Discontinuation Notice of Common sockets Part of Model PYF series.

Product Discontinuation

Part of Model PYF08A series
Model PYF08A-E
Part of Model PYF14A series
Model PYF14A-E

Model PYFZ-08 series
Model PYFZ-08-E
Model PYFZ-14 series
Model PYFZ-14-E

[Body color]

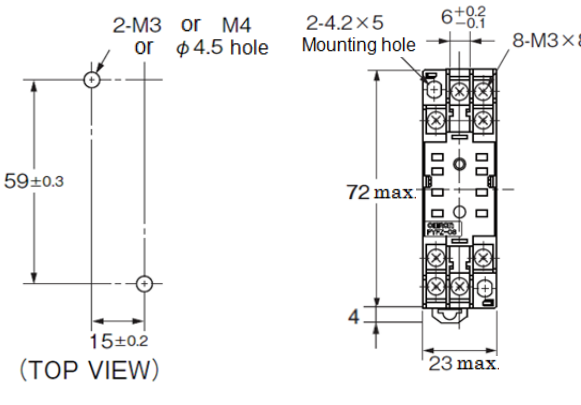
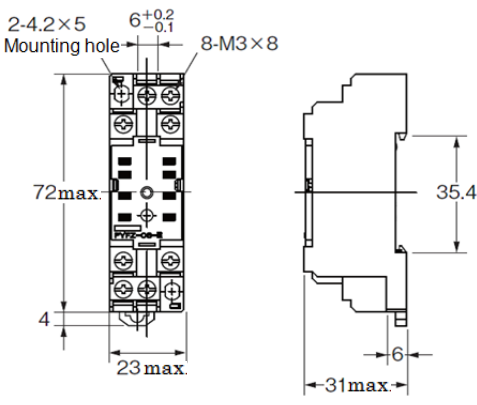
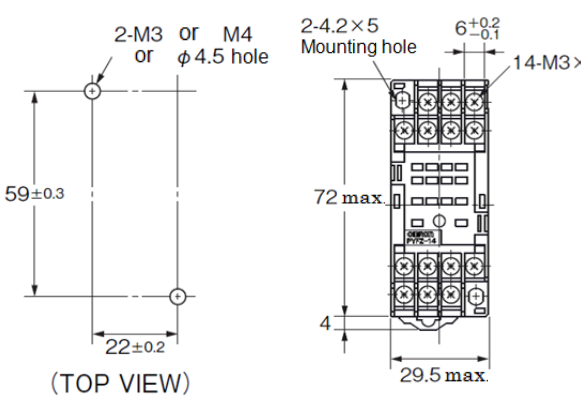
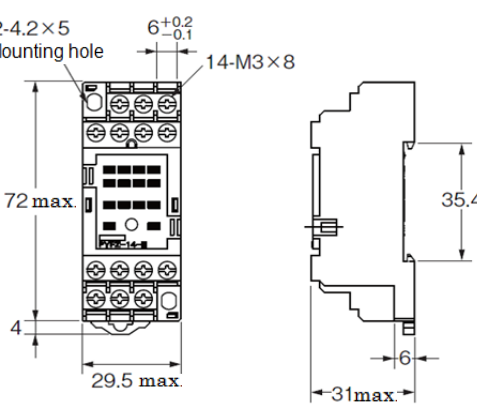
Product discontinuation Model PYF08A series, PYF08A-E Model PYF14A series, PYF14A-E		Recommendable replacement Model PYFZ-08 series, PYFZ-08-E Model PYFZ-14 series, PYFZ-14-E	
Body color: Black PYF08A series PYFZ-08 series  * Photo: PYFZ series		Body color: Black PYF14A series PYFZ-14 series  * Photo: PYFZ series	
		Body color: Black PYF08A-E PYFZ-08-E  * Photo: PYFZ series	
		Body color: Black PYF14A-E PYFZ-14-E  * Photo: PYFZ series

No changing
